TULSA METROPOLITAN AREA PLANNING COMMISSION

For Meeting No. 2565

November 4, 2009, 1:30 PM

Alternative Compliance Landscape Plan – East of the northeast corner of 71st Street South and Riverside Drive; Lot 3, Block 1 – Riverbridge West; 1415 East 71st Street South; TRS 8306; CZM 52; Atlas 1008; PD 18; CD 2; CS/OM/PUD-261-C.

ALTERNATIVE COMPLIANCE
LANDSCAPE PLAN

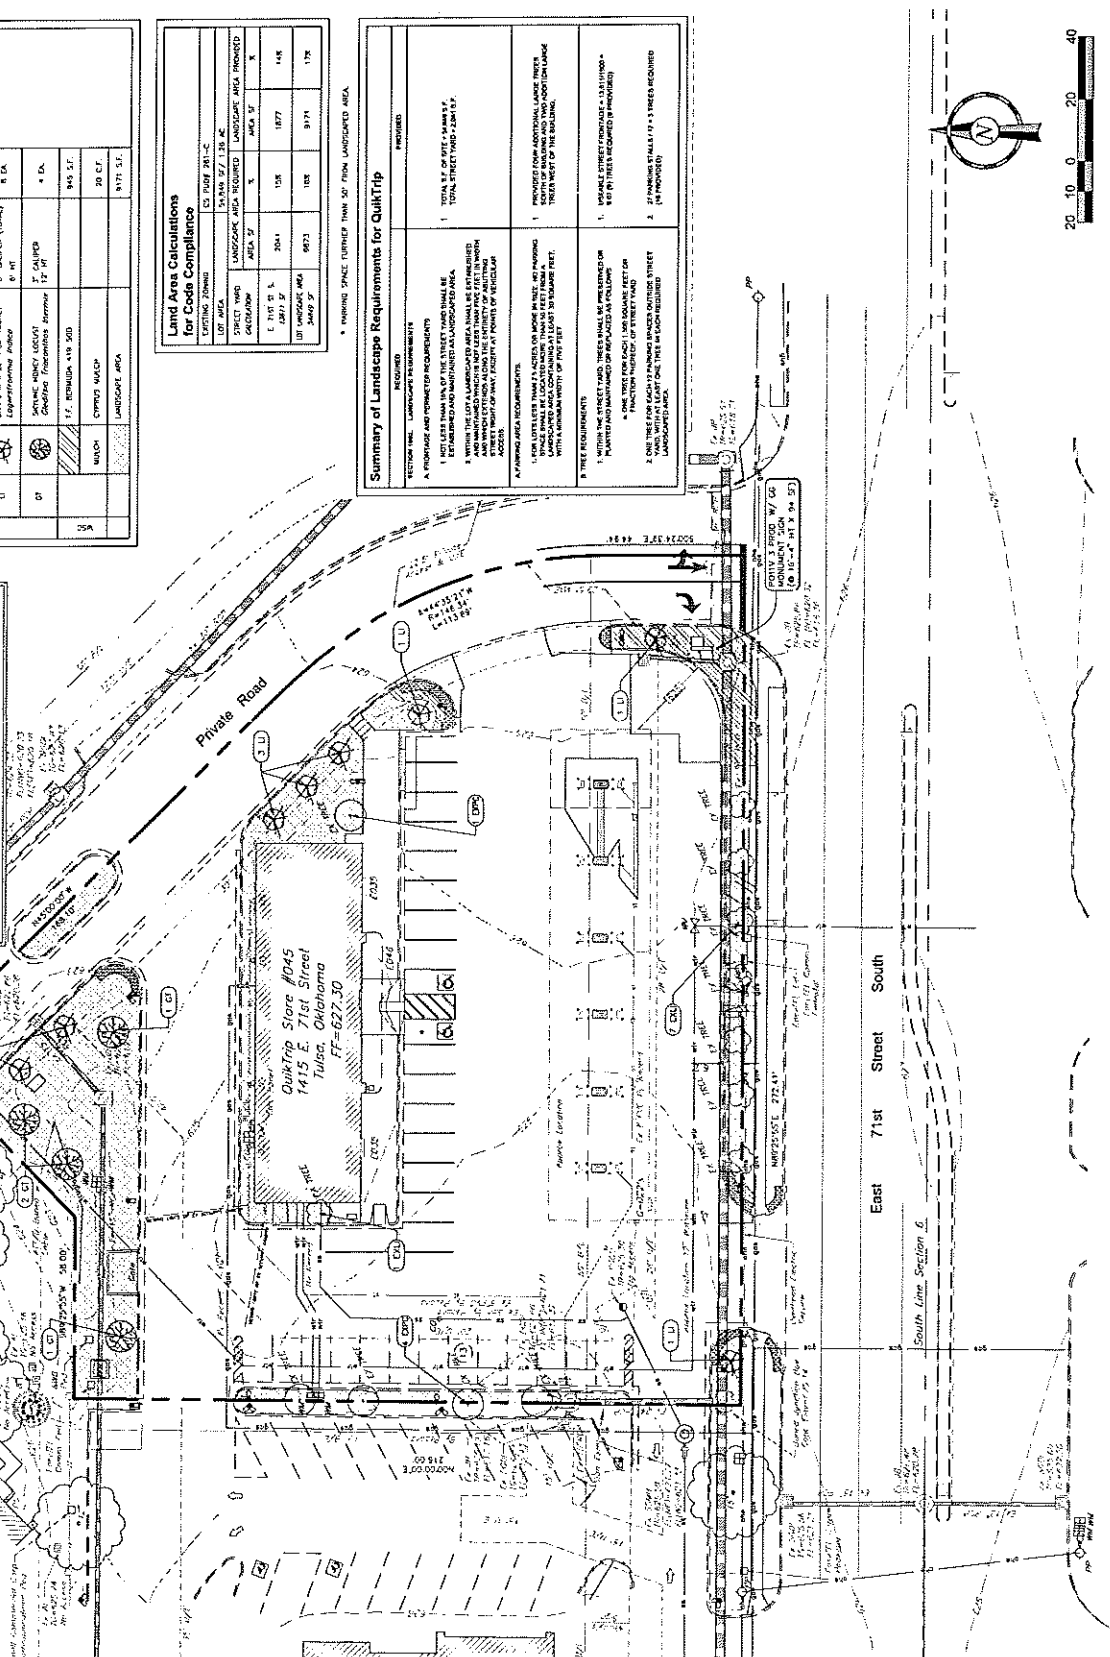
The applicant is requesting TMAPC approval of an alternative compliance landscape plan for a QuikTrip gas station and convenience store located at the above described location. This landscape alternative compliance plan is a modification of a previously approved landscape alternative compliance plan approved by the TMAPC on December 7, 1995 (see Exhibit A).

The re-examination of the landscape plan is being triggered by the expansion of the canopy over the fueling facility and the reconfiguration of the access point located at the southeast corner of the lot. The access reconfiguration should allow for easier ingress/egress to the site.

The plan does not meet the technical requirements of the code since the existing site does not meet the minimum PUD open space requirement of 18%; there is one space in front of the store that is not within 50' of a required landscape area; and the street yard along 71st Street is not 15% landscaped.

The applicant is proposing to put an additional 12 trees on the site. This will bring the number of trees on the site to 25; 13 trees over the required 12 trees.

Since the site will remain above the 10% open space required for commercial properties by the PUD chapter of the code and there will be 12 trees added to the 13 existing trees on site, staff feels the proposed plan meets or exceeds the technical requirements of chapter 10 of the code and meets the intent of §1000 of the code. Therefore staff recommends **APPROVAL** of alternative compliance landscape plan AC-94.
